ADDENDUM TO REPORT FOR ITEM LPP05 – 2 March 2022

SUBJECT: LPP05 -182 Kurraba Road, Kurraba Point

AUTHOR: John Mc Fadden Consultant Planner

10. Turning area, vehicle ramp removed from ‘private’ driveway.

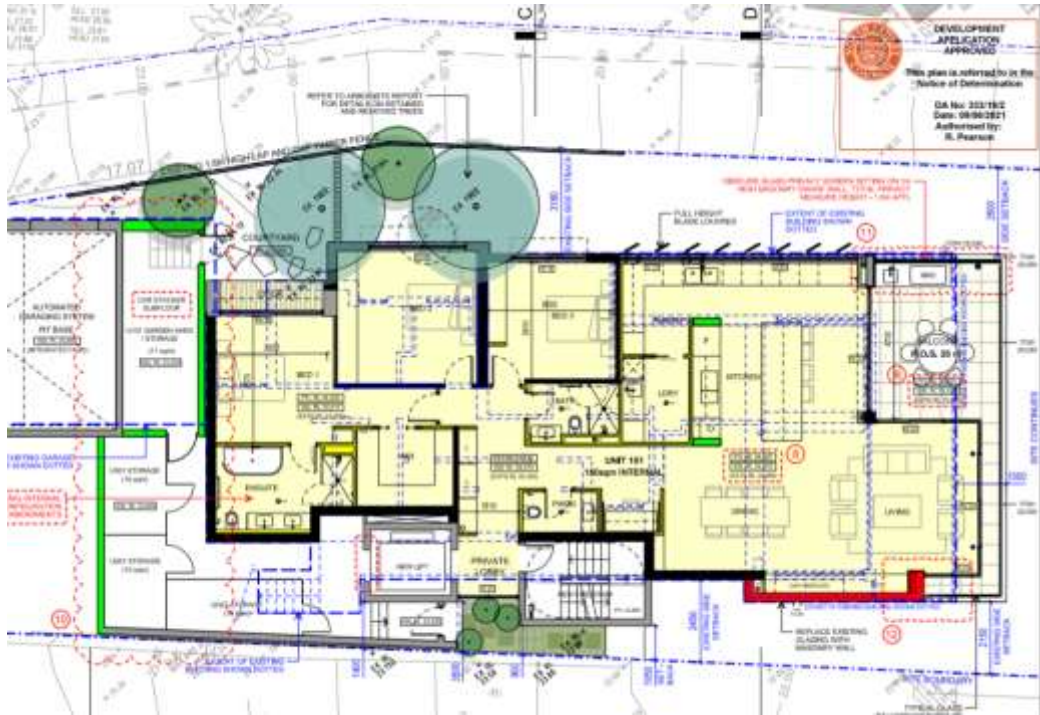
Comment: Vehicles from ‘stacker garage’ will reverse across driveway, visibility pedestrian safety issues.

Comment: The vehicle stacker, manoeuvring of vehicles in the driveway which is a ‘right of carriageway’, safety issues were considered by Council’s Traffic Engineer in the original assessment of DA 333/19. No objection was raised by that officer at the time and no changes to these parking arrangements are proposed by the current S4.55 application.

Mr McFadden’s report has clearly mis-read the objection raised as evidenced by his response which confuses movement along my driveway at 184 Kurraba Road with the cars reversing out of the property from the proposed car stacker at 182 Kurraba Road.

My objection clearly articulated that the issue was not only with vehicles reversing out of the proposed car stacker at 182 Kurraba Road. My objection was with the impact on vehicles coming and leaving my property via my driveway at 184 Kurraba Road and having no lines of sight, together with the multiple pedestrian entry and exit points proposed at 182 Kurraba Road which will be obstructed by the new 10m long, 3.5 m high walls with zero setback.....

The current S4.55 does not relate to any new configuration of the driveway, car stacker or vehicle maneuvering which was approved via DA333/19/2. The S.4.55 consideration cannot revisit other issues not associated with the current s.4.55 unless they are related. The current S.4.55 modification relates to balconies, windows and internal reconfiguration. The 10m long ‘new’ wall referred above (circled yellow below) was already approved via stamped plans issued by Council for the original DA 333/19.

Current S.4.55 plans of Ground floor.

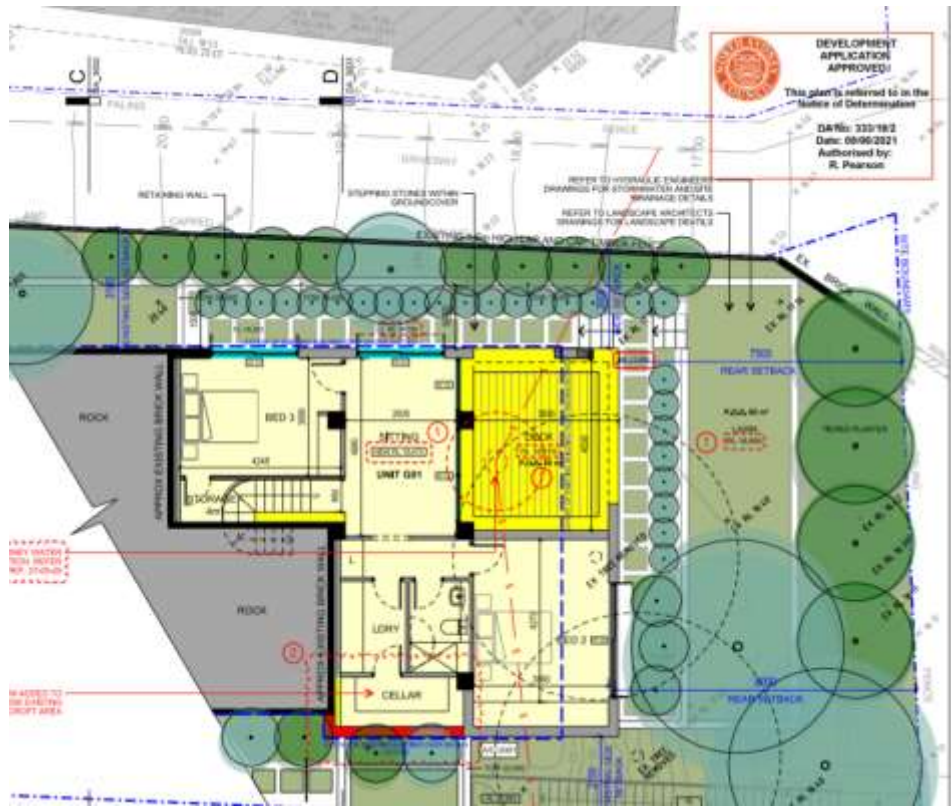
'I consider this to be a serious oversight which fails to address the concerns raised as a direct and impacted neighbour. On this basis alone, I ask that this matter be deferred from the Panel's agenda until such time that:

- a traffic study assessing the impacts of the access to and from the properties at 182, 184, 1/184A, 2/184A, 1/184B, 2/184B Kurraba Road is undertaken*
- a safety assessment is undertaken which investigates the impacts of the proposed new 10m long, 3.5m high wall with zero setback, and other walls with non-compliant setbacks adjacent to pedestrian exit points, which are proposed along our driveway at 184 Kurraba Road.'*

As can be seen the current 'Ground Floor Plans' of the current S.4.55 are basically identical to the last approved plans DA 333/19/2 and so the proposal was not referred back to Council Traffic Engineers as this elevation was largely unchanged (save the 'Lower Ground Floor Lower' laundry extension).

The current S.4.55 is unrelated to these matters and as the applicant already has Development Approval.

Approved Lower Ground Floor Plan Lower Approved via DA 333/19/2 .

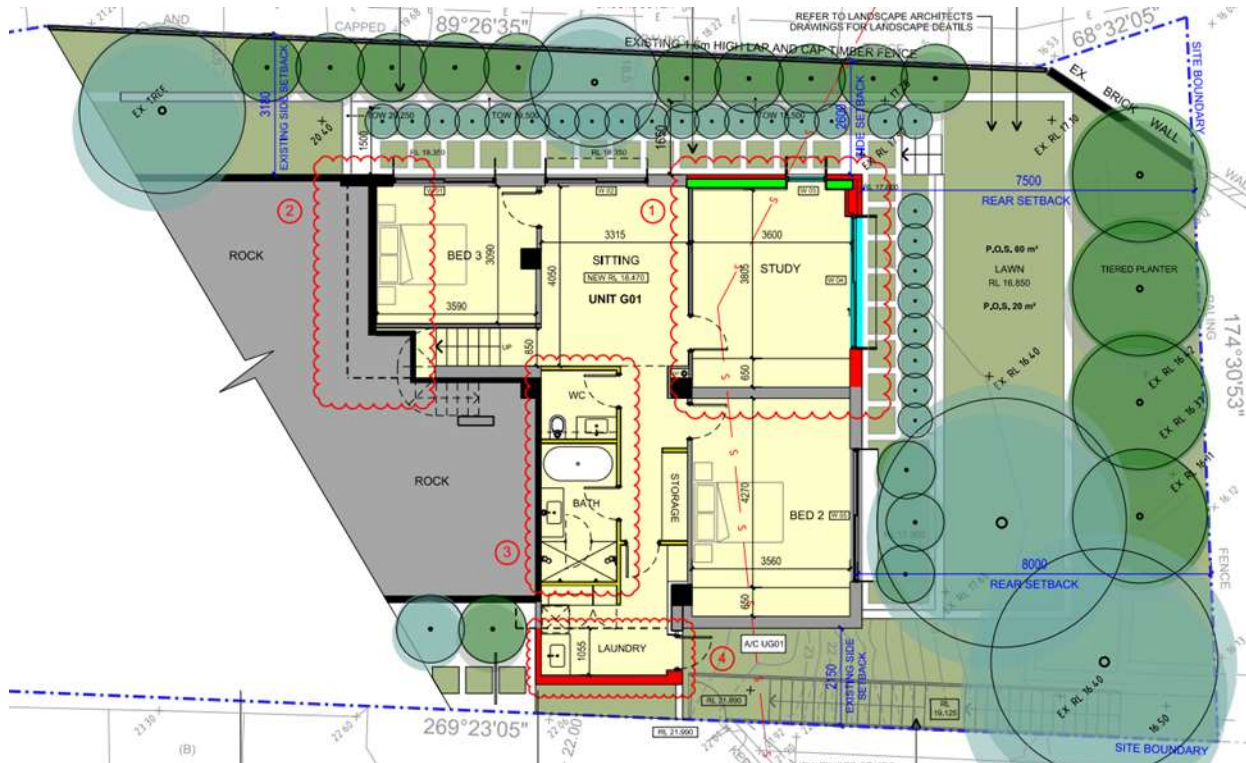
11) New encroachment by laundry wall to 0.6m.

Comment: There is a new 3.2m wide encroachment into the 1.5m southern setback requirement by the laundry on the Lower Ground Floor Plan (Lower). This has been mentioned in the report and being substantially in excavation, will have little impact on the adjoining property or driveway.

The area is not in excavation. Any breach(es) of the DCP require a merit-based assessment for each breach which considers the rationale and appropriateness of the non-compliance in addition to the impacts.

It is appreciated that there has been a request for an encroachment in the area of the previously approved cellar (see below).

Note the Finished Floor level of this unit, and, the new Laundry projection is RL18.47 whilst the adjacent driveway is approx. RL 22.00, the laundry is therefore 3.53m lower than the adjacent driveway. It is difficult to see what impact this laundry extension has.
